ASSESSMENT REPORT

Section 75W Modification Chester Hill Materials Recycling Facility (06_0052)

Figure 3: Site Layout as proposed in Modification

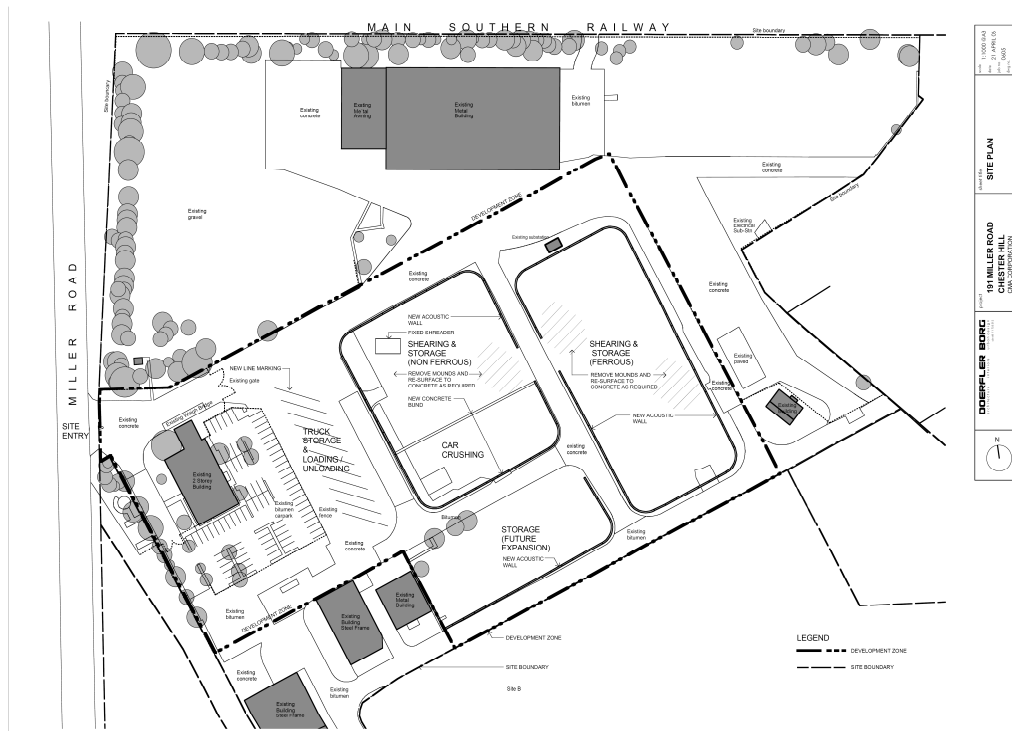
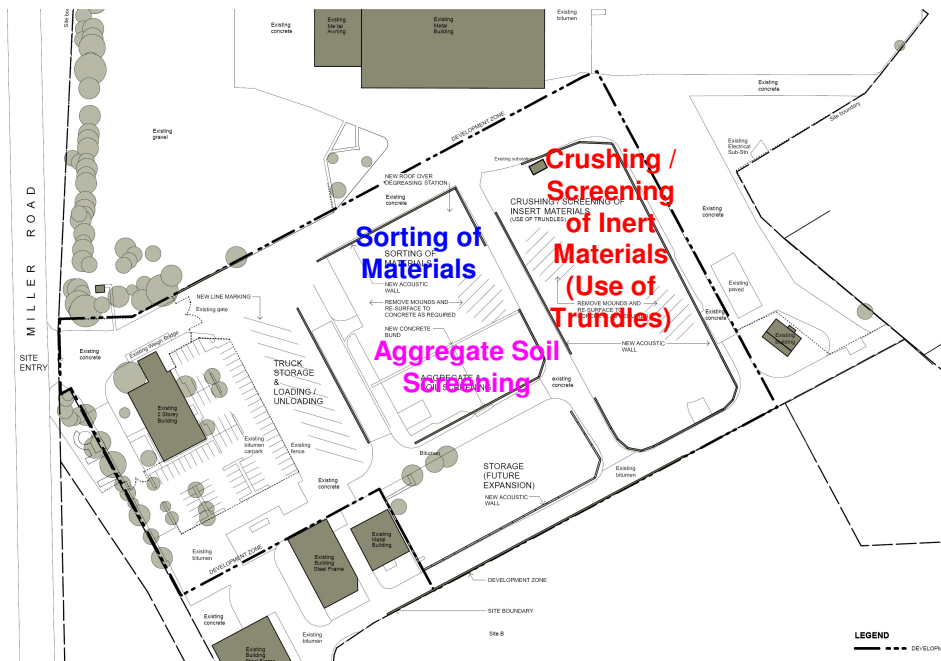
Components of the project that would be modified from the approved project are described in Table 1. These would include, minor modification to the alignment of the noise barriers, a variation in the processing plant and equipment, and the type of materials processed at the facility. Under the proposed modification, the recycling of metal would only comprise approximately 20% of the total volume of material to be processed at the facility. The modified project would incorporate the same site layout as detailed in the existing approval (see Figure 3).

Figure 4: Proposed Noise Barriers

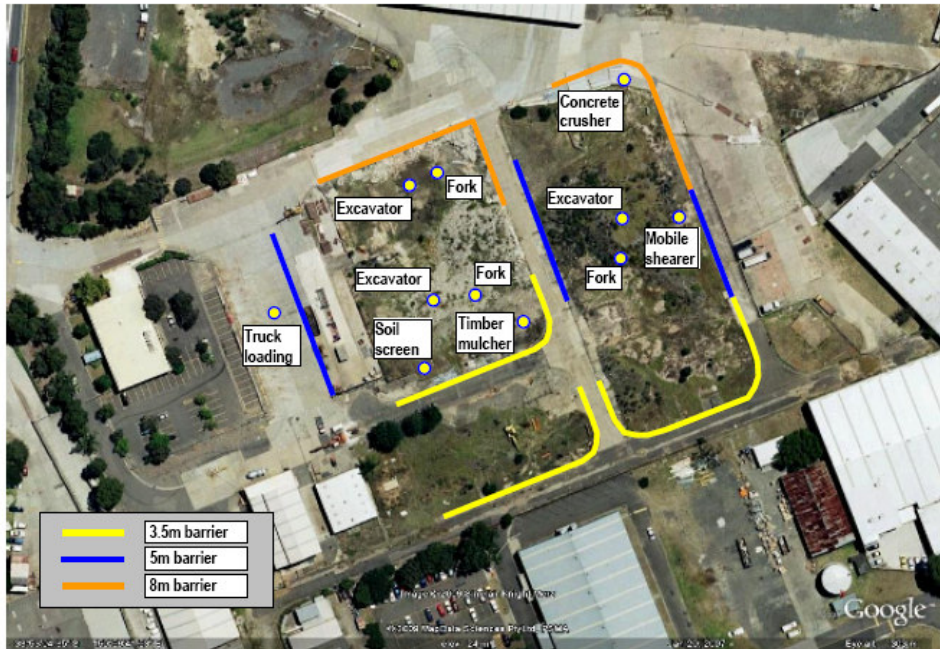
No.1 Demolition proposes to slightly modify the alignment of the noise barriers from the existing project in accordance with those specified in Spectrum Acoustics' noise assessment. Further, No.1 Demolition proposes to limit operation of heavy machinery to between 7am and 5pm on weekdays, and ensure that no material processing activities are conducted outside of the noise barriers.

Council raised concerns that the noise assessment indicates that residential properties along Waldron Road would experience noise levels that exceed the noise criteria.

The existing project approval contains the noise criteria established by NSS which include noise criteria of 42 dB(A) at Waldron Road residences and 45 dB(A) at Orchard Road residences. When assessed against the approved noise criteria, the predicted noise levels for the modified project are 2 dB or more below the criteria.

The Department considers that appropriate measures have been incorporated into the project design to ensure noise impacts are appropriately mitigated and the PSNL can be achieved.
